## RESPONSE TO THE PEER REVIEW OF THE ACOUSTIC ASSESSMENT FOR THE PROPOSED HIGHLAND LINE PIT LANARK HIGHLAND TOWNSHIP, ONTARIO

Please find below our response to the Peer Review by Jade Acoustics, dated 14 April 2025 of the “Acoustic Assessment for the Proposed Highland Line Pit, Lanark Highland Township, Ontario”, dated 23 September 2022, prepared by Freefield Ltd. (Freefield) on behalf of Thomas Cavanagh Construction Limited.

- 14.3 Figure 1: Showing proposed haul route and Analysis of Alternative Routes (Source: MHBC)

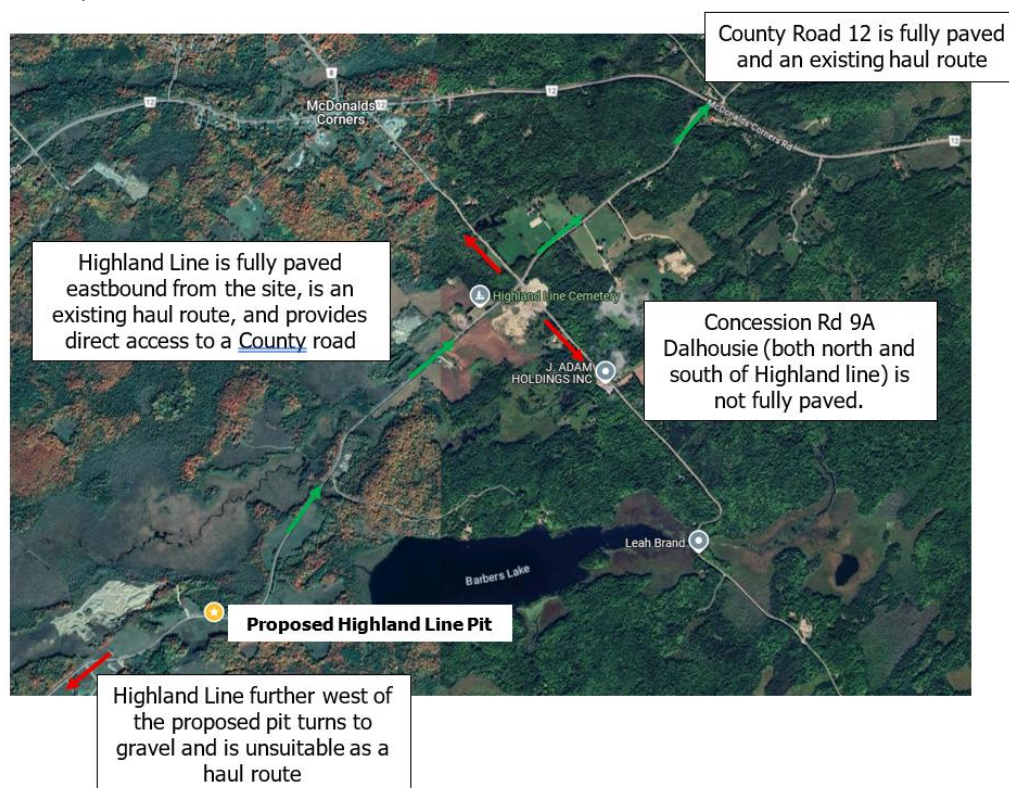
14. As discussed with the municipality, for completeness, an analysis of the off-site haul routes should also be included in the updated noise report.

- 14.1 An analysis of the off-site haul routes is typically carried out for new sites not on an existing haul route in order to analyse alternative routes to determine the haul route with least impact. The proposed Highland Line Pit is located on an existing haul route.

- 14.2 Irrespective of this, the proposed off-site truck traffic (off-site haul route) will travel east on Highland Line for approximately 2.7 km before connecting onto County Road 12. This is a significantly shorter haul route with far fewer residences, potentially impacted, compared to the alternative options. Given that the residential dwellings, in both east and westerly directions from the site, are at similar setbacks from Highland Line, the proposed haul route represents the haul route with the least impact. The proposed off-site Haul Route is shown on Figure 1 below.

- 14.4 To further address the public concerns related to truck traffic on Highland Line, the proposed hours of operations have been reduced to daytime hours only (07:00 – 19:00), and the maximum number of trucks (loads) leaving the site per hour has been reduced from thirty (30) to fifteen (15) per hour in total. Refer to Updated AAR, Section 2, pg. 6.
